COLUMBIA GENERATING STATION, DOCKET NO. 50-397 RESPONSE TO REQUEST FOR ADDITIONAL INFORMATION LICENSE RENEWAL APPLICATION

Enclosure 1: Photographs (3) Cooling Tower Plume at Columbia

RESPONSE TO REQUEST FOR ADDITIONAL INFORMATION

Photo 1 - Plume from the west on a cool day with relatively stable atmospheric conditions.

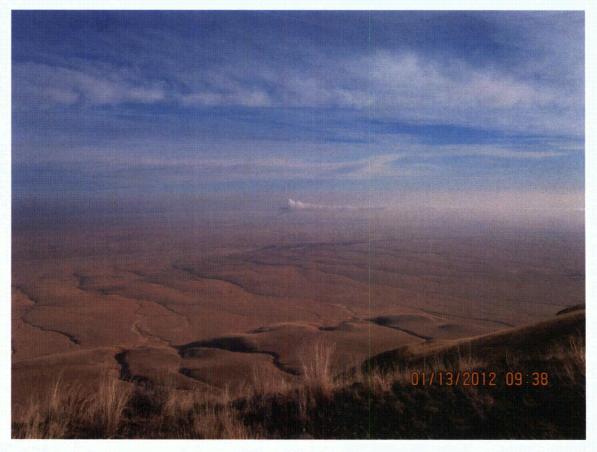
1. For the purposes of describing the visual impact of Columbia Generating Station, provide a general description of the aerial plume of condensation from the mechanical draft cooling towers. For example, when is it typically visible (months of the year, time of day, approximate temperature ranges)? Provide an estimate of the typical height of the plume, when visible. Does it have any noteworthy visual characteristics?

The enclosed photographs help show the seasonal variation in visible plume lengths. Photo #1 shows the plume from the west on a cool day with a relatively stable atmosphere. Photo #2 shows the plume from a location on the ridgeline of Rattlesnake Mountain approximately 13 miles from Columbia on a hazy January morning with air temperatures less than 0°C. Photo #3 shows the plume from the southwest on a warm day.
